Rotherhithe to Canary Wharf River Crossing

Value Engineering

Transport for London

04 October 2018

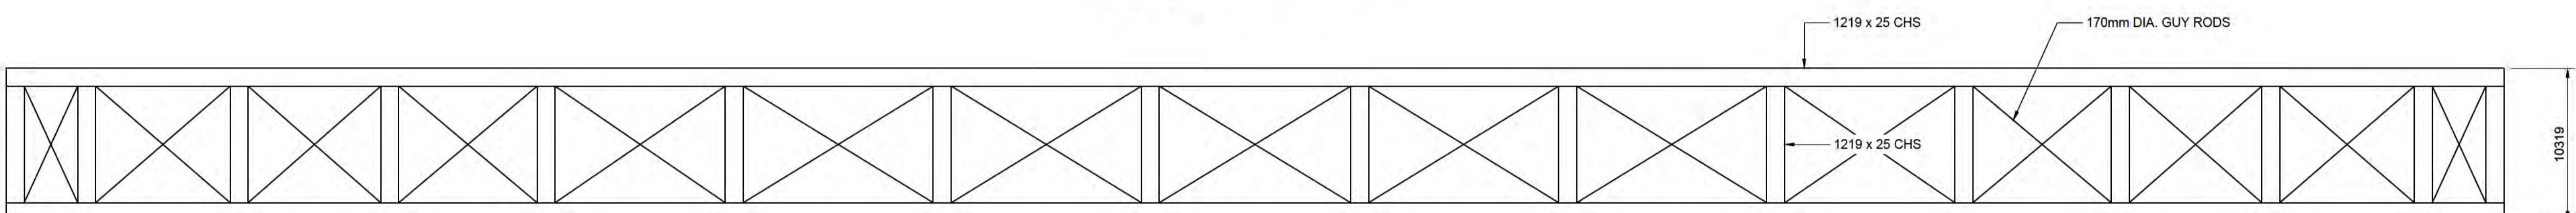
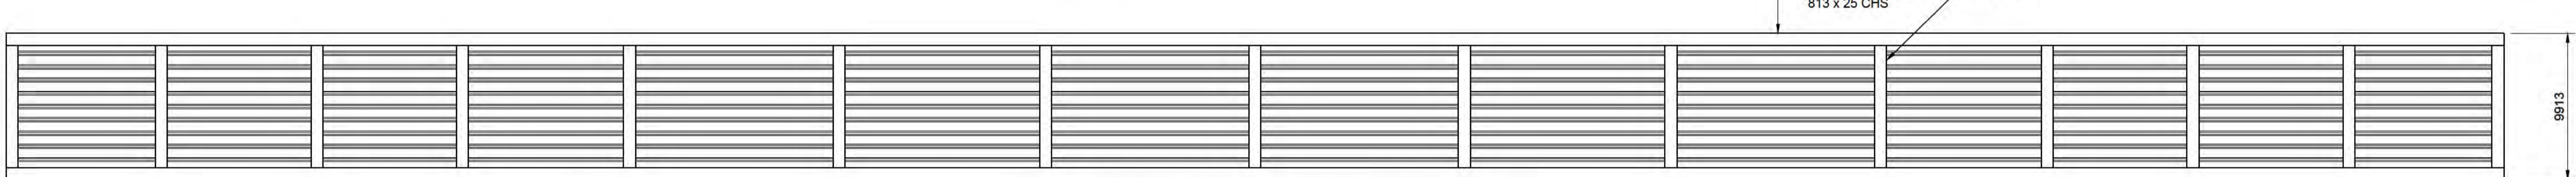
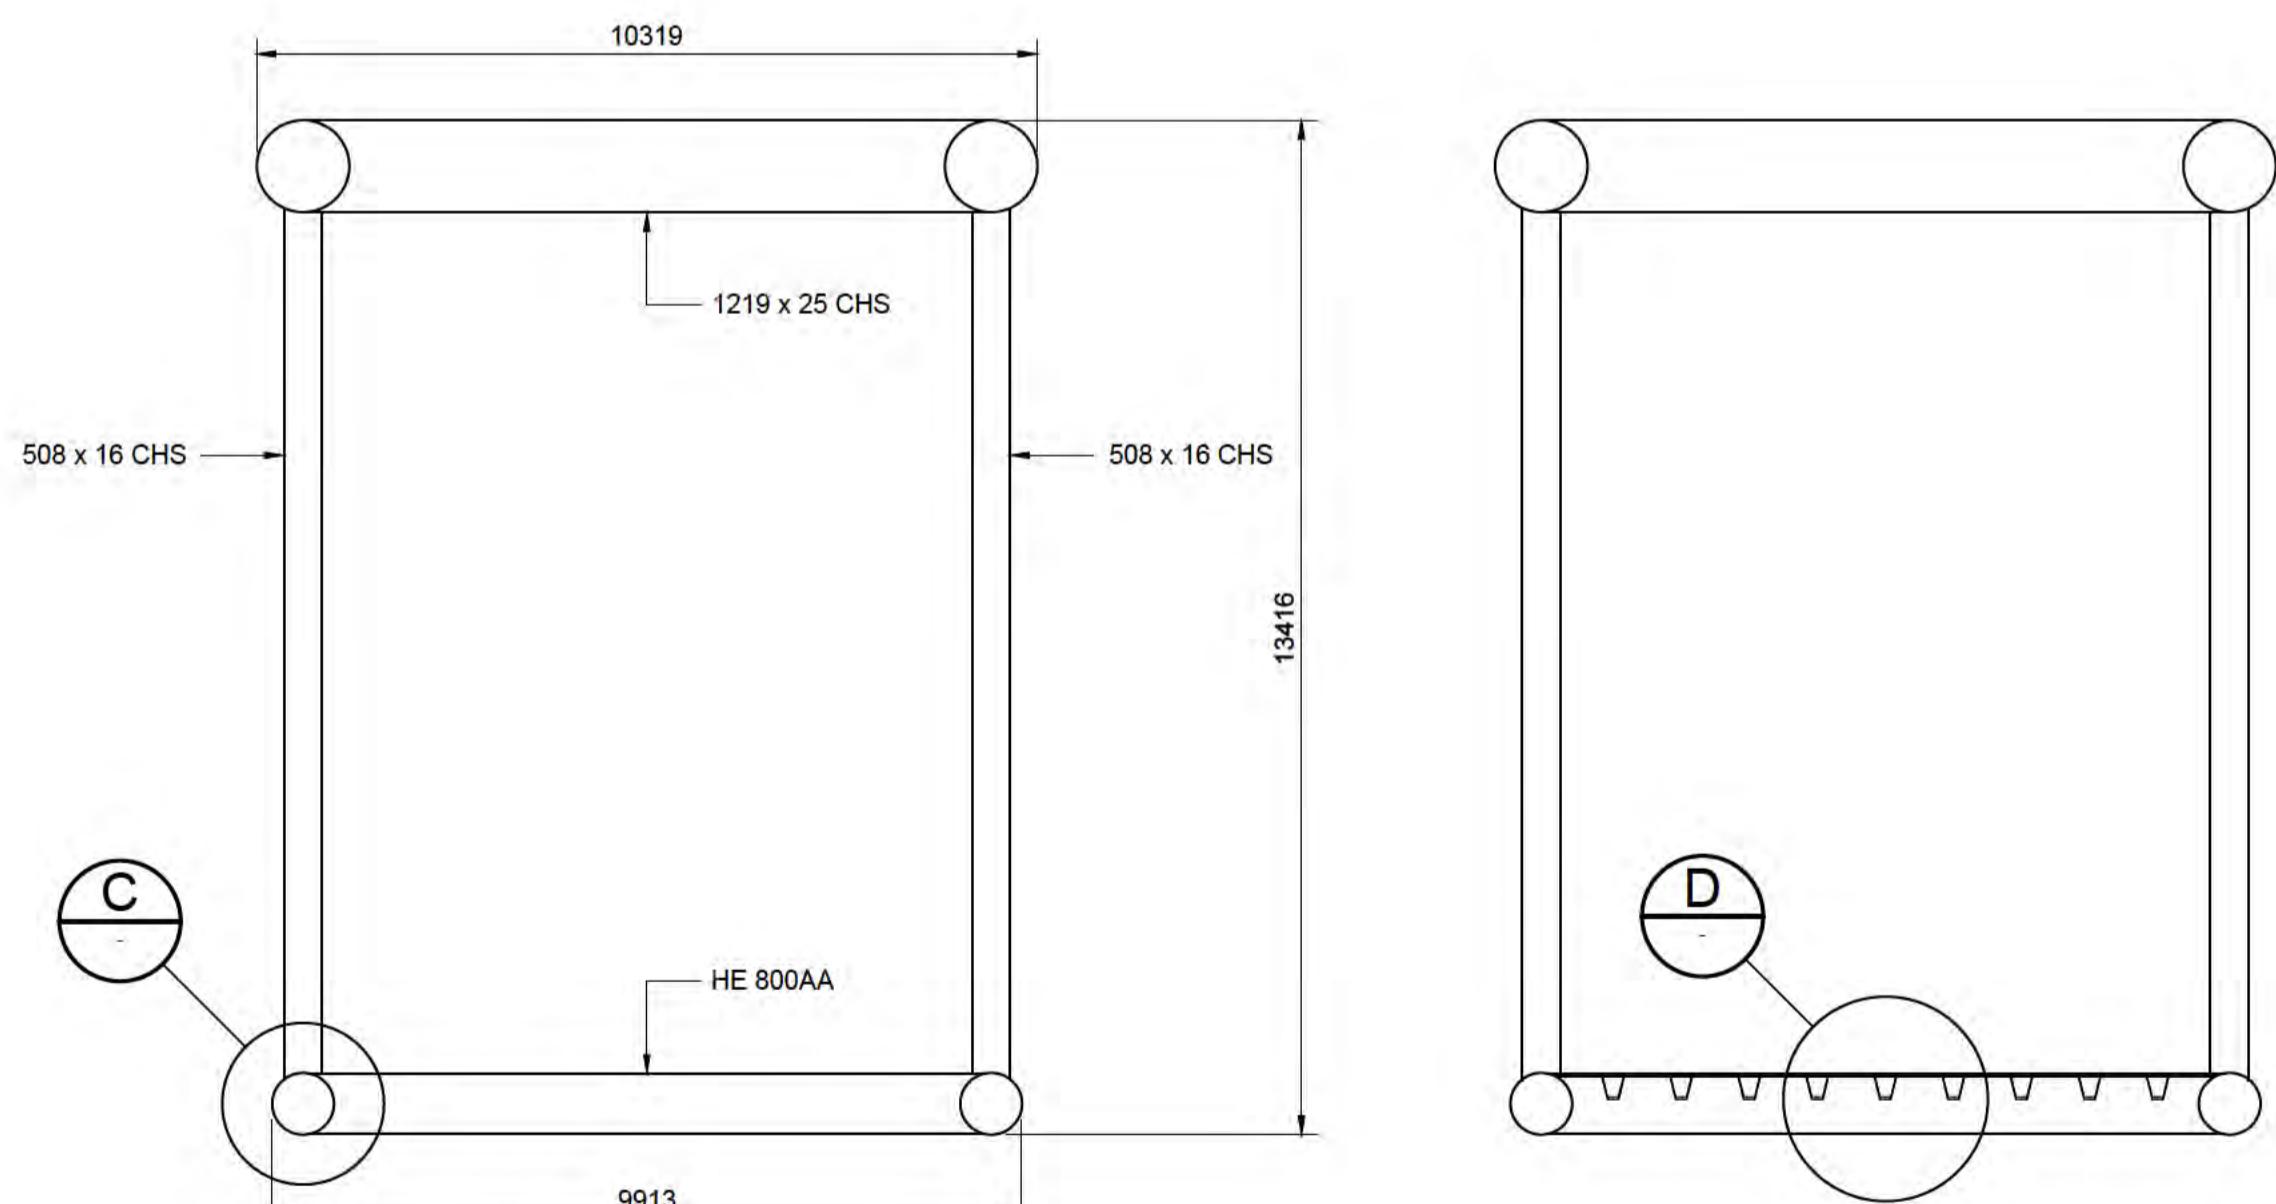
Refer to ST_PJ585C-ATK-BAS-ZZ_21-DRG-ST-00004 for a General Arrangement Drawing for VE19.

Figure 1 - Steel Tower option (Concept design)

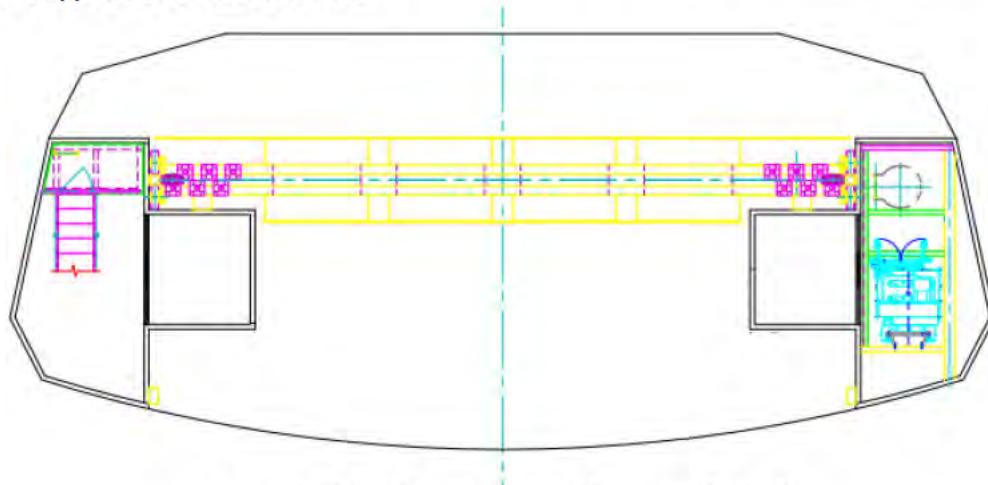
The baseline design considers steel sections for the 80m tall tower proposed for the vertical lift of the bridge deck. The steel plate of 80mm thick is considered in the baseline design for the towers (Ref.: ST_PJ585C-ATK-BAS-ZZ_09-DRG-ST-00003). It will be fabricated to the desired shape and installed with significant stiffener rings/diaphragms at the intermediate floors of the stairs, approx. 4m to control buckling. The provision of intermediate stiffeners rings/diaphragms in one of the tower will be complex to allow space proofing for the lift shaft. Painting of tower is required for maintenance and for better aesthetics. The current concept design for the towers has refined and it is currently 55mm thick section at the bottom and the section thickness varies gradually till the top of the tower (Refer Figure 1). The weight of the tower is approx. 900 tonnes of steel.

The VE23 is to propose the steel truss tower for the 75m height and the top 5m will comprise of rotors, M&E equipments with a service floor deck. The current proposal of the truss tower comprises uniform CHS sections with bracings and can potentially be reduced along the height during the detailed design stage. For the steel truss option, the lift shaft & staircase are not considered as it is uneconomical and require higher space inside the truss. Ladders (to be attached at the rear side of the truss) separated by floors at various levels is considered for maintenance operations. The counterweights at either side will be split in two and will be located inside the truss tower with cable hangers & sheaves at top. The weight of the truss tower is approx. 250 tonnes of steel and is comparatively lesser than the steel plate tower.
